We sincerely hope you are able to support a refusal on this retrospective planning application P/66/26/PL.

Heritage Statement and Appraisal concerning land to the north of , Nyetimber Forge, Pagham.

This statement has been prepared to offer an evaluation of the alterations that have been taking place without permission at land with reference to Planning Applications lodged with Arun District Council, references P/165/25/PL (withdrawn) and P/66/26/PL.

I am writing to you on behalf of Mr Rawlins, Barton Manor to **object** to the following planning application:

From the Planning Application

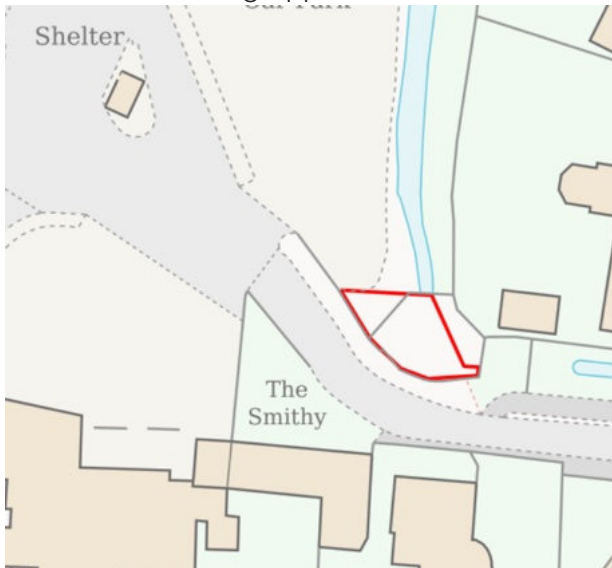
Whilst the scope of this report focuses on the heritage impact of the alterations, the preparation of the maps and diagrams for this document shows significant discrepancies between the site boundaries declared on the application site plan and current aerial mapping. The alterations have not only exceeded the declared site area but also affected the public highway land verging Barton Close.

The site prior to the alterations (comparison with previous page)

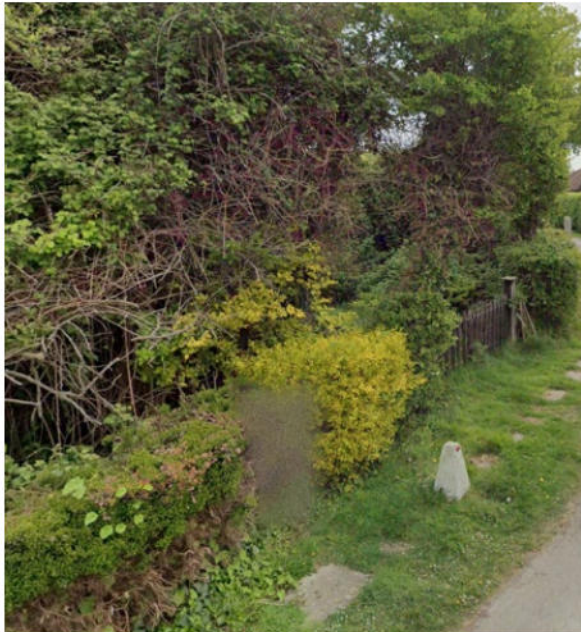
Since the dates of this imagery, the vegetation has been removed, the permeable gravel surface has been installed and the boundary treatments completely altered. It is clear to see that this has significantly affected the setting of the Listed building. The land had been acquired and covenanted by Barton Manor and was used as a small garden space by Nyetimber Forge, visible in Streetview images of 2012 which shows the semi-rural vegetation to each side of the site that characterised the scene.

In the 2025 Planning application, reference was made to the site already serving as space for two cars, however, the aerial and Streetview imagery shows that this cannot have been the case, and that the provision of car parking was first introduced during the work undertaken in 2022-23 for which the 2025 application sought to regularise. General Planning law advice states that Planning permission is likely to be required to convert undeveloped land into private parking space.

The information given in the 2025 and 2026 application forms also claim that no new vehicle access from the highway is involved, yet there was previously no vehicular access and the applicant has installed a double-width crossover to the highway without permission.

The following images taken from google earth show that the unlawful change of use which included the addition of car parking occurred prior to the 29th April 2023.

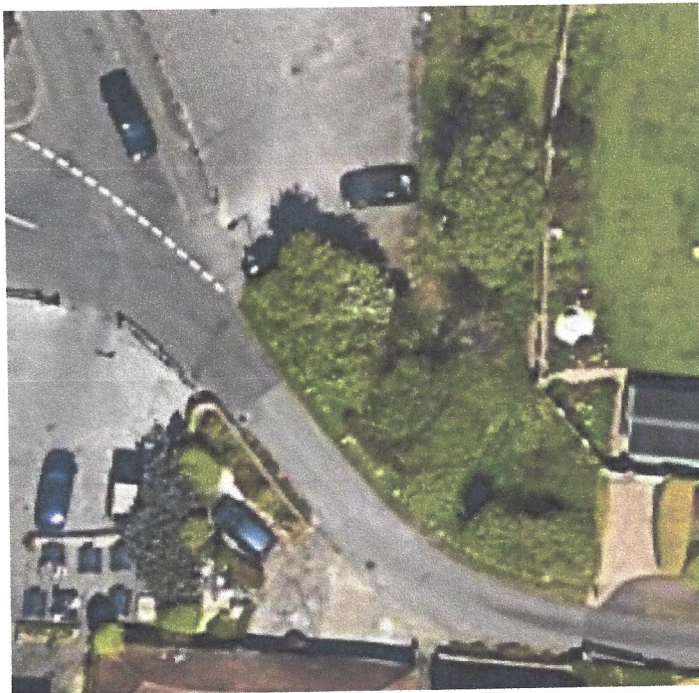
The land to the north of Nyetimber was originally an undeveloped area of dense soft landscaping that provided a verdant setting to the entrance to Barton Close. The stones laid within the verge provided an informal path/refuge area for pedestrians around the bend in the road. The land was not a residential garden and did not form part of the curtilage of Nyetimber.

2022 (Before the addition of the car park)

29.4.23 (After the addition of the car park)

The description of the planning application must be amended to make it clear that the application seeks a change of use from landscaping to residential car parking. All parties and consultees should be advised of the amended description and invited to update their comments. Failure to do so would render any permission vulnerable to a legal challenge by judicial review.
